Design Review Report – Item 1

Local government:	City of Stirling	
Item no.:	Item 1 - DA24/1064 – 308 Main Street, Balcatta – Development Assessment Panel – Form 1 – Child Care Premise	
Acting Chairperson:	Philip Gresley	
Panel members:	Tony Blackwell Jackson Liew Lisa Shine	
Local government officers:	Peter Prendergast James Fletcher Dean Williams Shaun Wheatland Simone Palmer	Acting Manager Acting Service Lead Planning Coordinator Planning Senior Planning Officer DRP Support Officer
Observers		
Date:	29 August 2024	Time: 3pm
Venue:	City of Stirling – Challenger Room

Design quality evaluation Item 1 – DA24/1064 – 308 Main Street, Balcatta – Development Assessment Panel – Form 1 – Child Care Premise DRP Meeting – Thursday 29 August 2024		
	S	<i>Design Principle satisfied</i>
	P	<i>Design Principle pending further attention</i>
	N	<i>Design Principle not satisfied</i>
Principle 1 Context and character		<i>Good design responds to and enhances the distinctive characteristics of a local area, contributing to a sense of place.</i>
	N	1a. Whilst the location of the proposal (and some technical contextual issues) was presented, the Panel noted that there was limited information provided

PROPOSED SITE PLAN

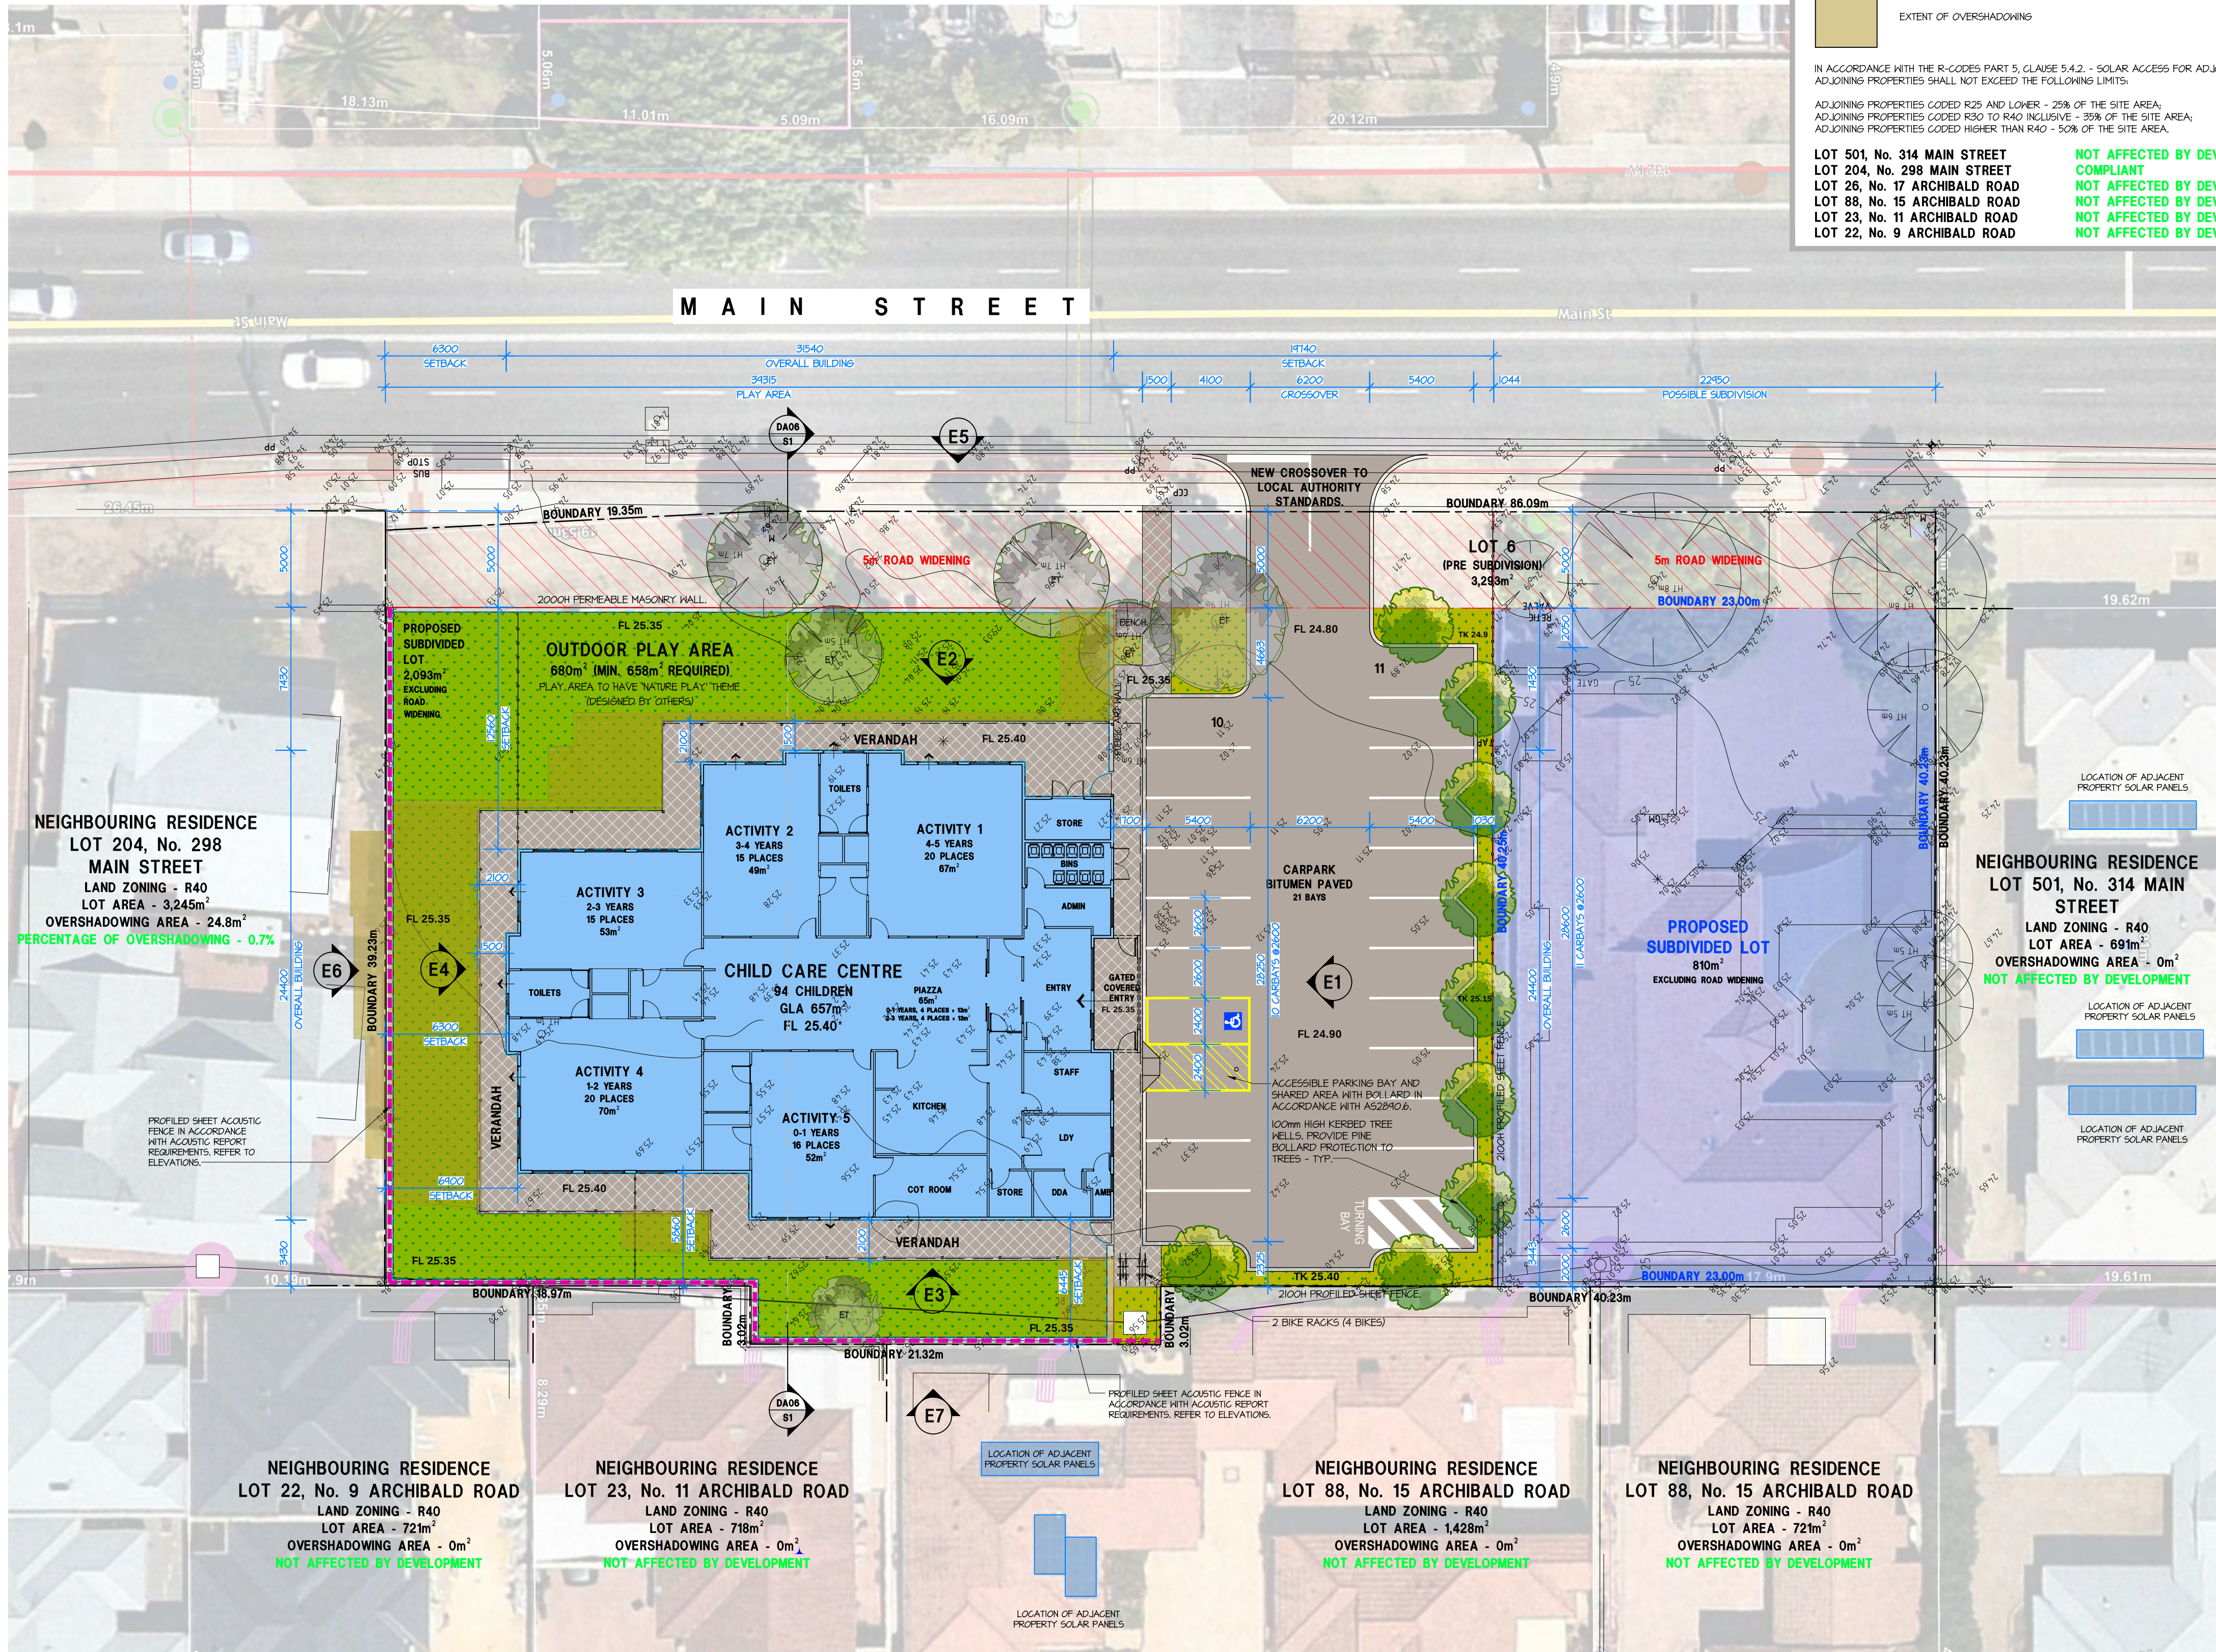
2h.	The Panel requested further clarification around the hybrid turf. There is opportunity for the Applicant to demonstrate the hybrid turf is a suitable product.			
2j.	It was suggested by the Panel there is an opportunity for smaller trees in the open space to better screen the carpark.			
3b	The placement of the car park to the north of the site significantly

reduces the opportunities for access to northern light for the building for passive solar design. The current proposal also introduces service areas and other functions to the north façade that do not require the benefit of northern light. Consideration should be made to relocate the carpark to the south of the building plus re-planning the building to face activity spaces north wherever possible, with connection to north facing outdoor areas. 3c. It is acknowledged that there are technical issues that create more difficulty in relocating the carpark to the south. It was suggested that due to the proposed road widening there may be opportunity for repositioning of the bus stop and drainage to more readily enable a crossover in that location. 3d. Should the relocation of the carpark not be possible, the Applicant should reconsider the design to demonstrate better access to northern light for better amenity and passive solar design.

6c.	The space defined by the safety fence and gates to the entry way could be more generous.			
7a.	The Panel stated the legibility of the entry portico could be examined and improved. It was suggested the generosity of this area could be explored.			
7b.	The Applicant was encouraged to explore screening the carpark with landscape or a visually permeable element which would add to the pedestrian experience and reduce the visual dominance of car spaces.

8a. Comment was made the entry portal and pathway seems too narrow. The Applicant was urged to check the width to ensure people can pass if a pram is being pushed at the same time. 8c. The Applicant was encouraged to separate the pedestrian and vehicular paths.			
10a. The current proposal in form is reminiscent of a more suburban retail outlet and would benefit from consideration of its use in its design. 10b. As explained under Principle 1 commentary there is opportunity to revise the selection of materials to include those of a more contextual nature. One suggestion was to consider the use of brickwork (even as a feature element) which is contextual to the local area. Investigate the various colours in the area or a certain type of brick which has been used. 10c. Whilst the simplicity of form is acknowledged the building form should be enhanced to better represent the use and to better respond to the quality of the streetscape. 10d. The front fence should be further developed to create more interest and better integrate the landscaping. 10e. The use of lightweight materials requires good architectural detailing to optimize the aesthetic outcomes. It would be beneficial to have a better understanding and detailing around the robustness of the materials utilised in the design to ensure a good outcome. 10f. Any shade sails proposed should be shown on the drawings and

PROPOSED FLOOR PLAN
SCALE 1:100 @ A1 1:200 @ A3

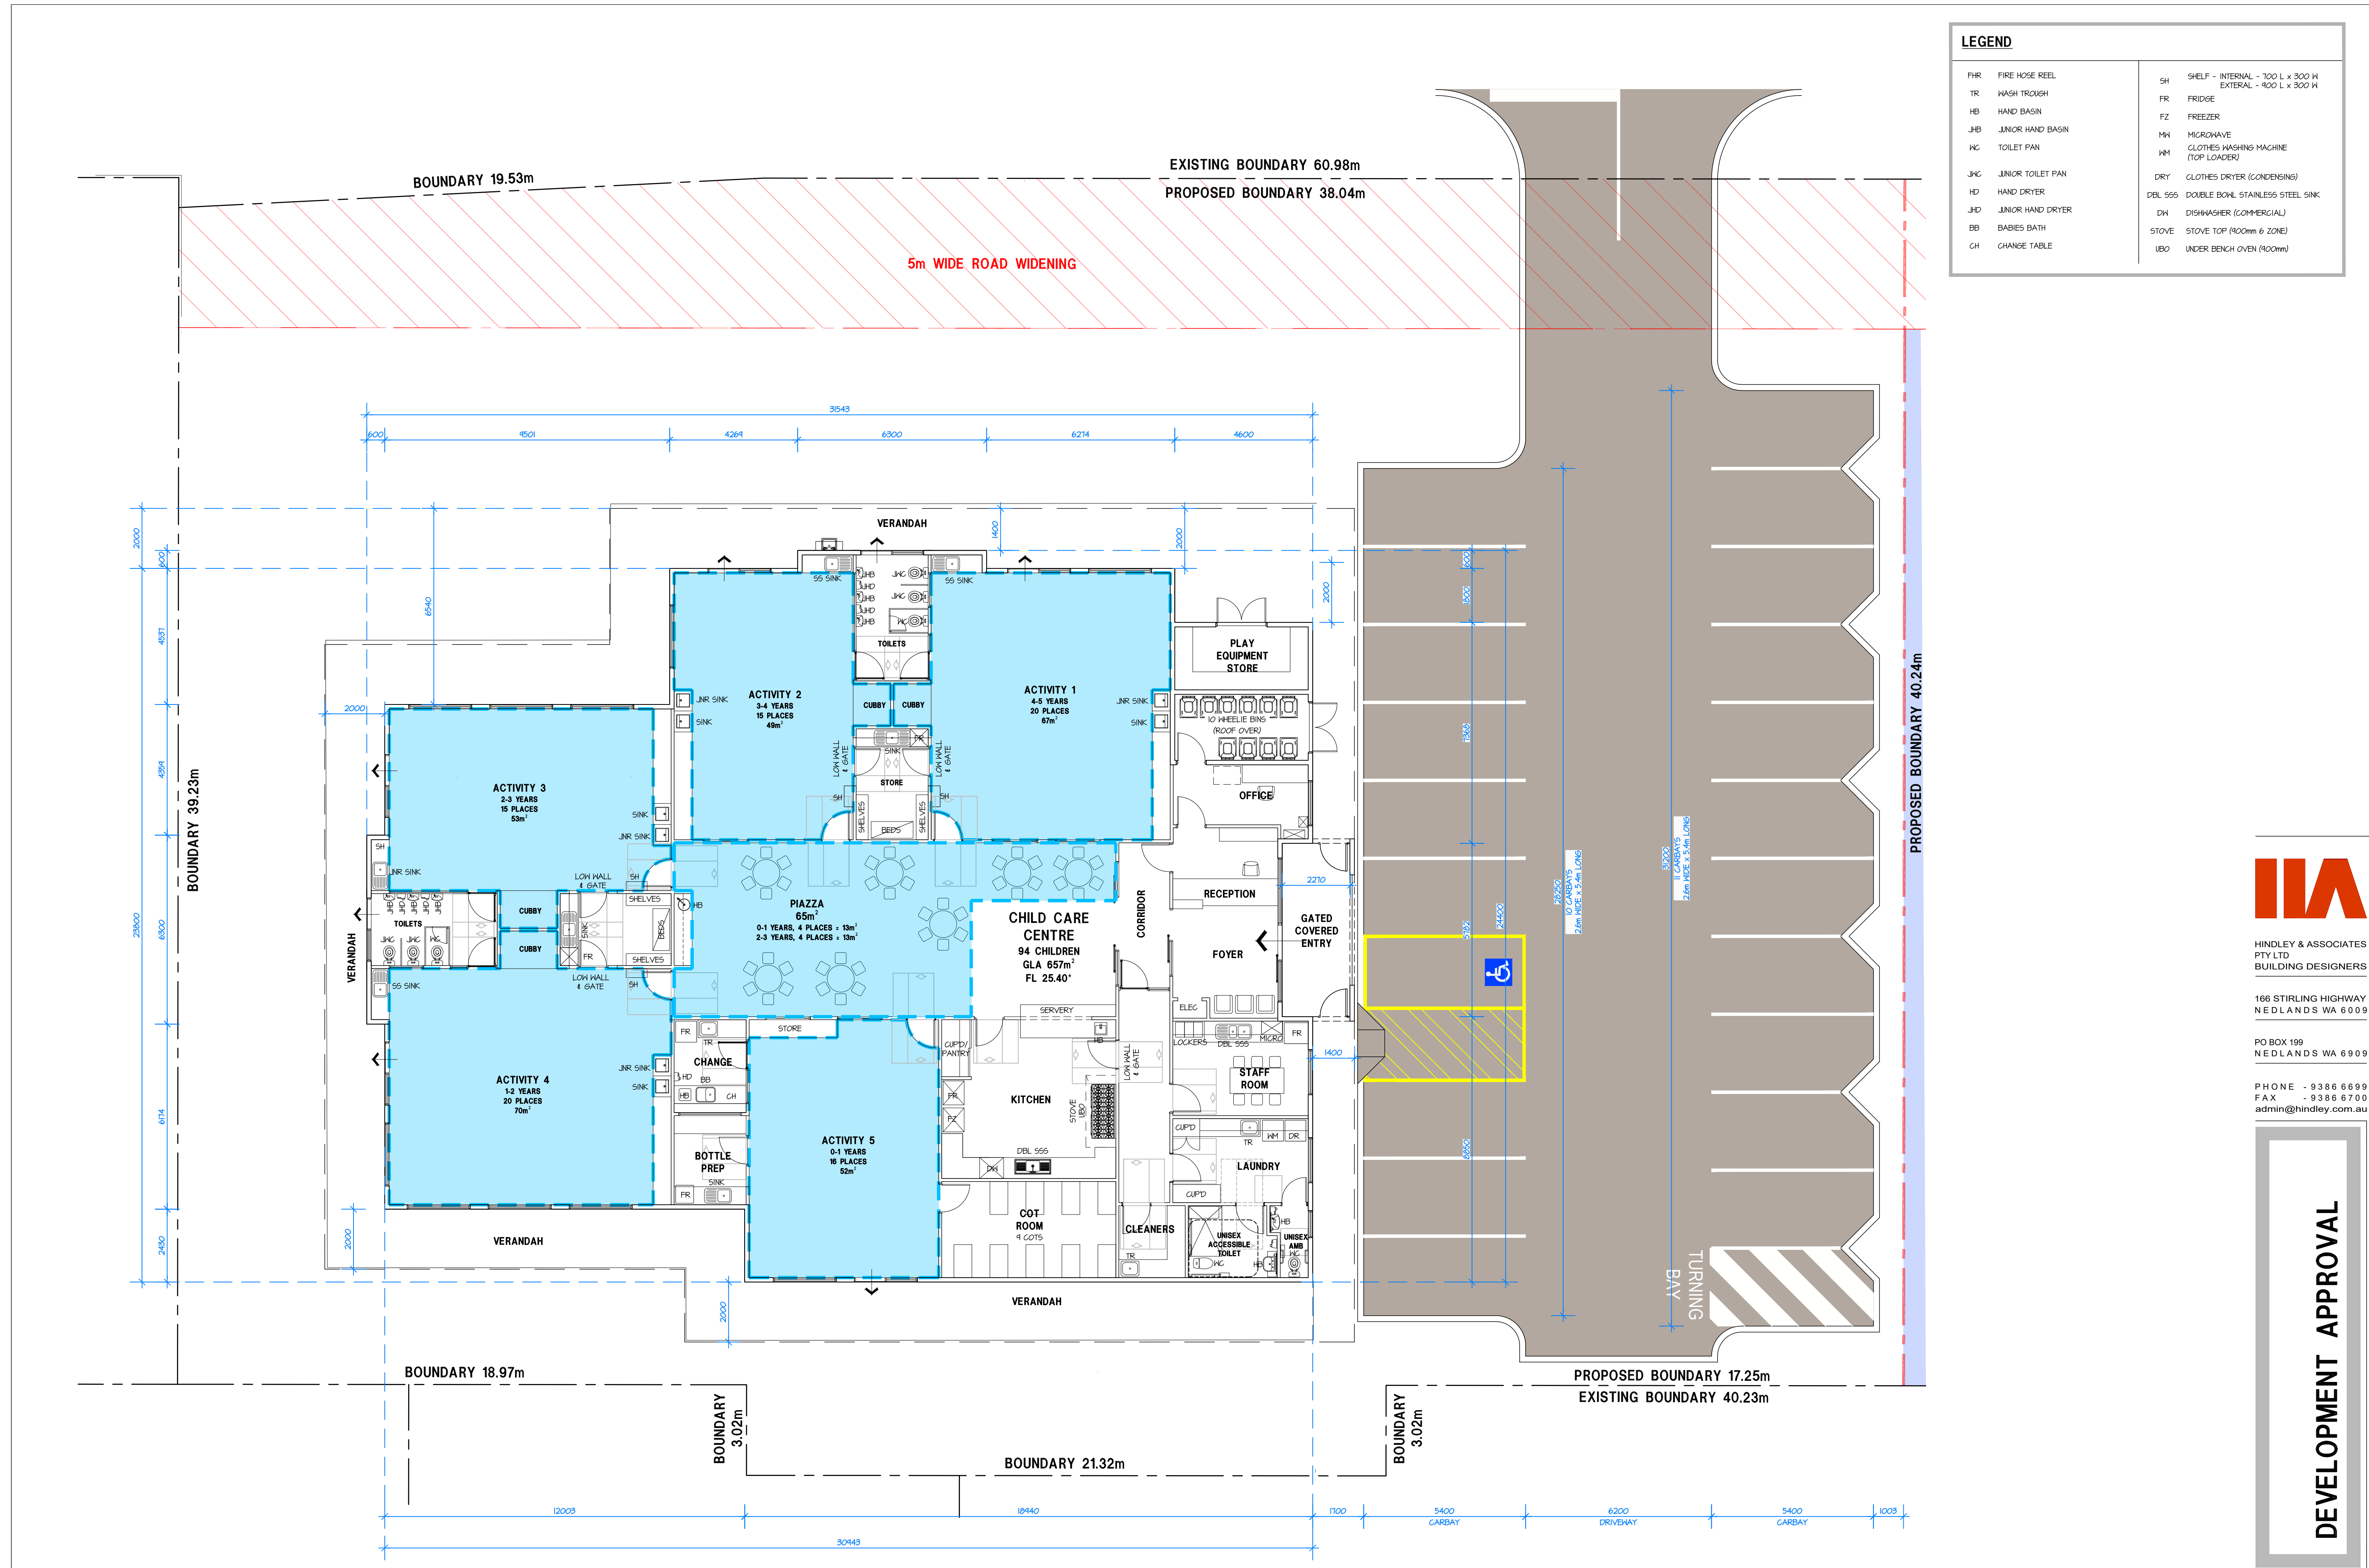
4b. The Panel commented that the centralised “piazza” circulation area works well from a ventilation and light access point of view. However, it seems to be its own separate activity space and included in the calculations for child activity spaces. The Panel questioned how this area will function if all activity spaces circulate kids through this space at the same time. Further clarification and an explanation on how this works would be beneficial. This also applies to the kitchen access to the “piazza” space. Although this

might work well, how will this be managed? 4c. The Panel support the operable highlight windows in the central space, however there is some concern about the effectiveness of the ventilation if there are no openings (fixed or operable) between the activity spaces and the “piazza” space to optimize the stack effect. 4d. Comment was made there is room for improvement around the arrival experience. It was suggested the entry could be relocated closer to the front corner of the building which could create more generosity of space (currently limited by the low safety fence), better legibility, a more welcoming entry, whilst improving proximity to the community seating area. 4e. The Panel expressed concern about the bin store being in such close proximity to the entrance. It was recommended the bin store should be repositioned to a more remote location away from the entrance due to possible odour issues and the visual aspect. 4f. The bin doors are not shown on the elevation drawings. The door handles popping out could be problematic if people are walking past. It was suggested there could be a slight recess to accommodate the bin store or recessed door handles to assist with this. 4g. The Applicant stated in their presentation the design is adaptable to other uses. The Panel commented the adaptability is not evident and further clarification is requested to understand this better.
